**BONITA SPRINGS, FLORIDA
COMMUNITY DEVELOPMENT DEPARTMENT
ZONING DIVISION
STAFF REPORT**

PROJECT NAME: TELCOFACILITIES DATA CENTER

TYPE OF CASE: SPECIAL EXCEPTION

CASE NUMBER: SPE24-118640-BOS

SPECIAL EXCEPTION SITE PLAN
REVISED MAY 16, 2025

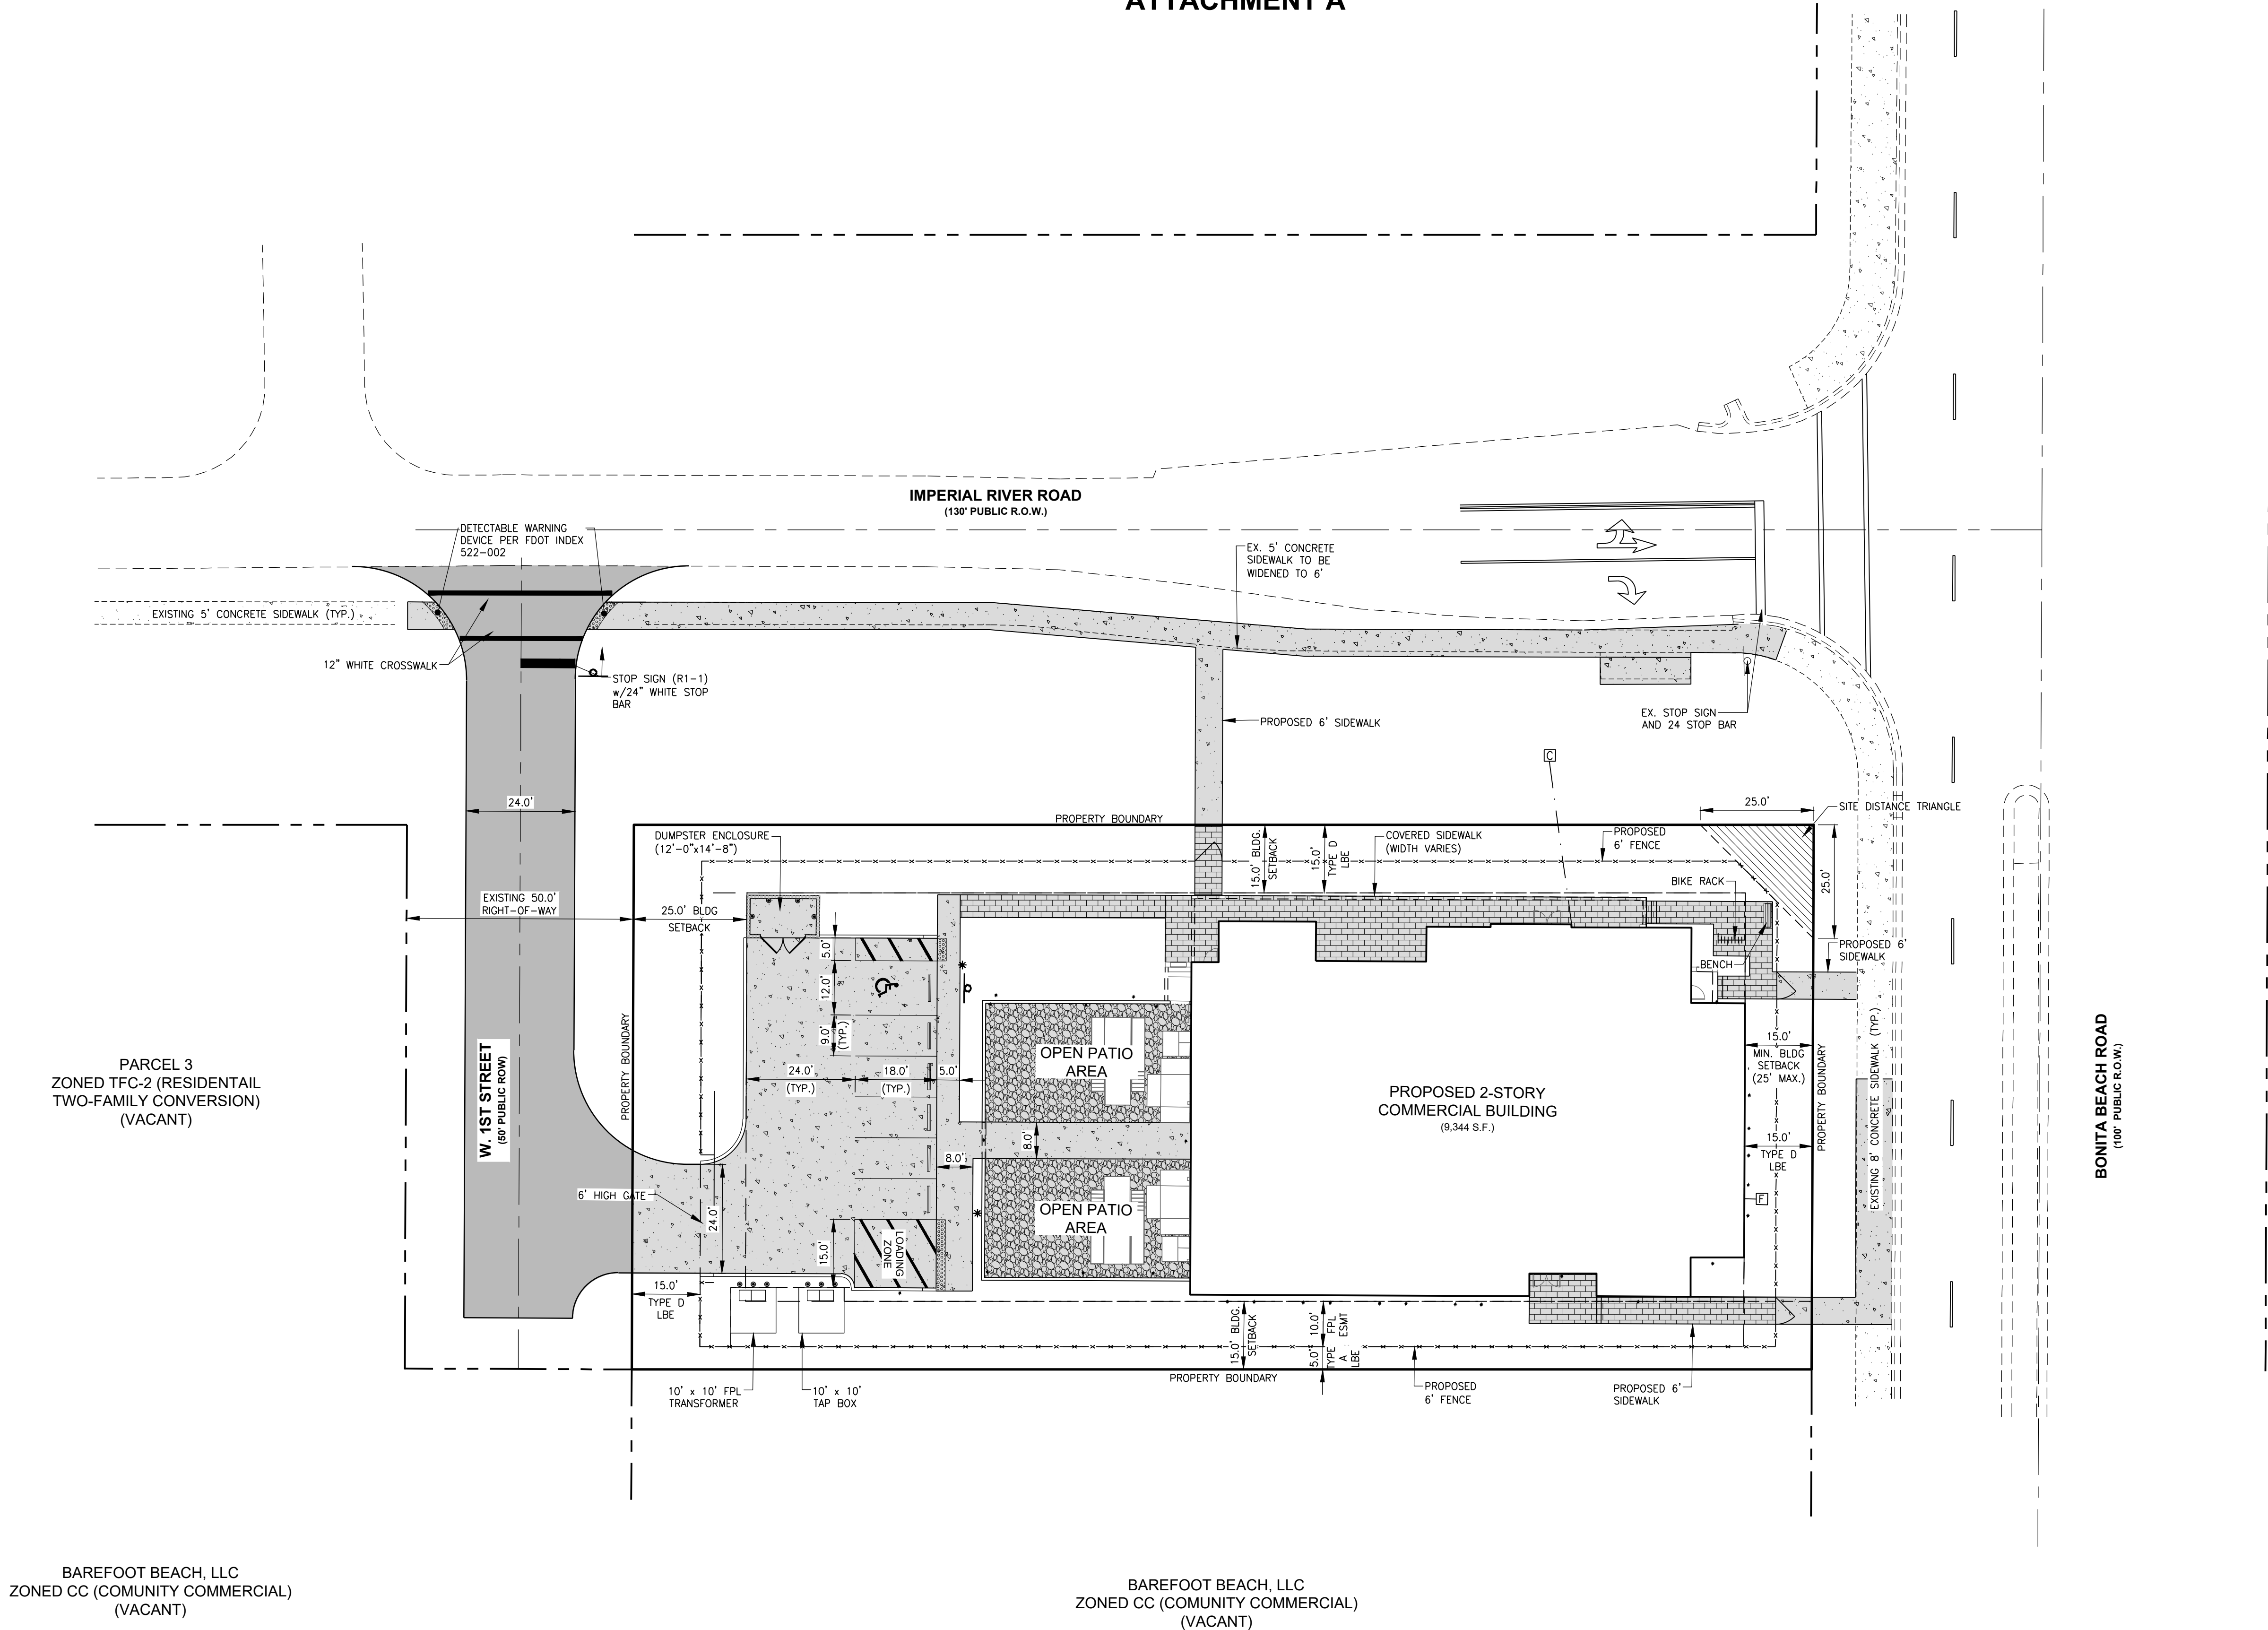
1. The project shall be generally consistent with the proposed site plan (Attachment A) and architectural elevations (Attachment B).
2. On-site parking is permitted to only be provided for the office portion of the data center. Should the data center use cease to operate and if a new use is proposed, a detailed parking analysis will need to be provided to determine whether the existing parking is adequate to support that use. If the analysis determines that additional parking is required, the site must be brought in to compliance unless an alternative parking standard is approved by the City.

4. The Applicant is responsible for the build out of W. 1st Street in order to provide suitable access to the property, as shown on the site plan. The street shall be built according to the standards of the City's Land Development Code regulations.
